Silken Sewing Ltd (New) (Extension Building)

14th March 2022

1. Woven Building (Partially eight storied) (reinforced concrete structure)

Observations

Live load table (BNBC 2020)

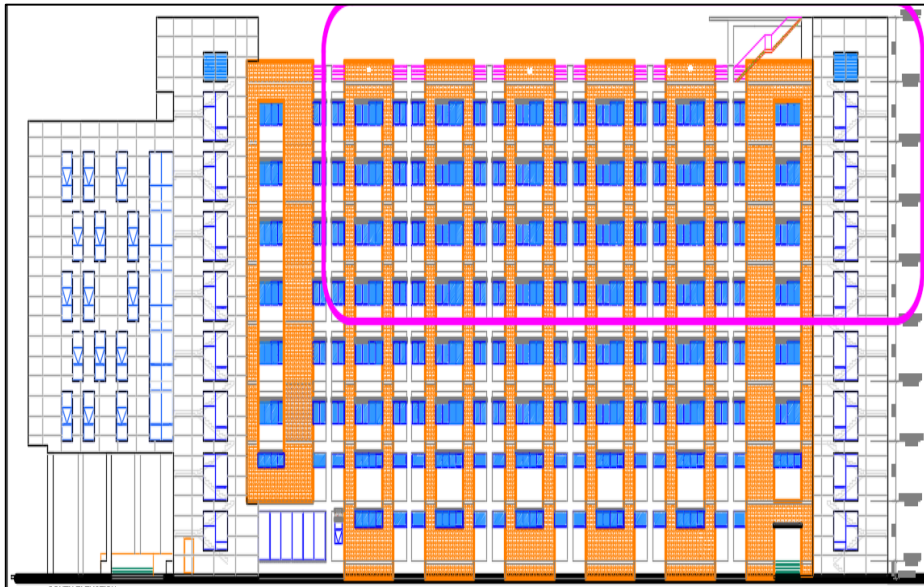
Live load plan- 3rd to 6th floor 4.8 kPa (100 psf)

Live load on typical floor (3rd to top floor) is considered as 4.8 kPa in prepared load plan. As per BNBC-2020, live load for light storage areas is required to be considered minimum 6 kPa. However, the factory engineer is required to revise the load plan as per BNBC requirement and check the design accordingly.

Building is designed as 8 storied

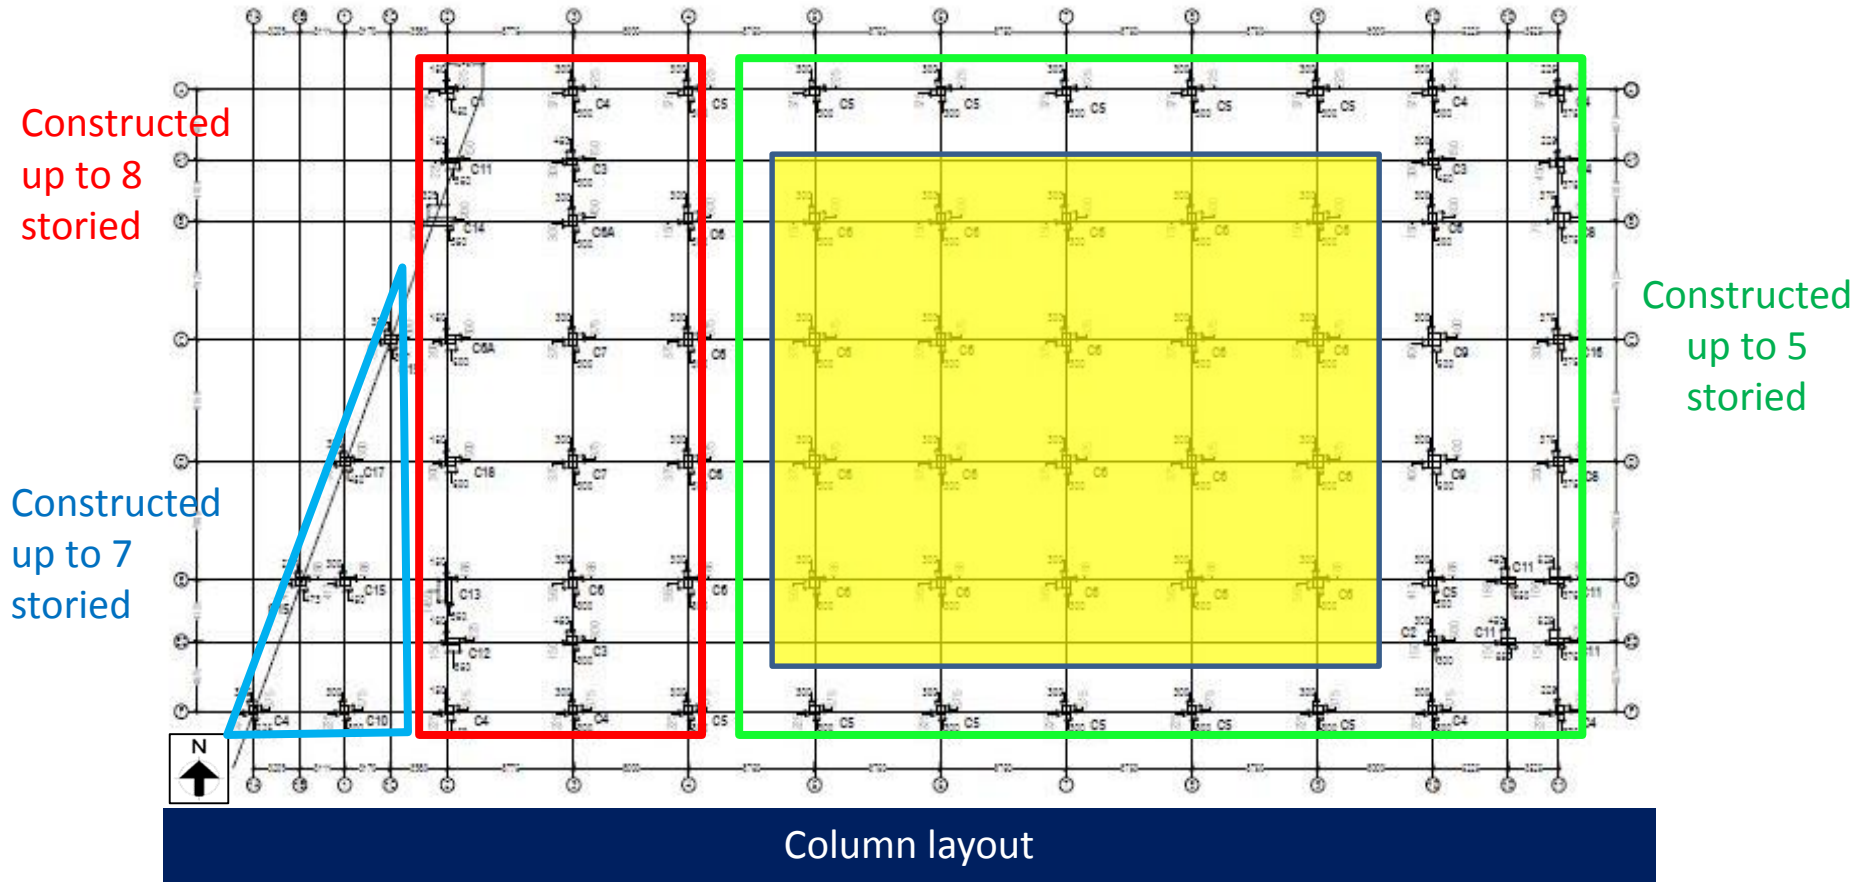
Ongoing vertical extension

The building has permit drawing for 8 storied and factory is conducting vertical extension on five storied part.

Building is currently partially 8 storied

Ongoing construction on 5th floor

Cursory calculation indicates the stress in highlighted column in layout (yellow marked) will be exceeded normal design limit for above of 7 storied. Factory engineer is required to review, design of column stress and prepare a Detail Engineering Assessment (DEA) report prior conducting any vertical extension.
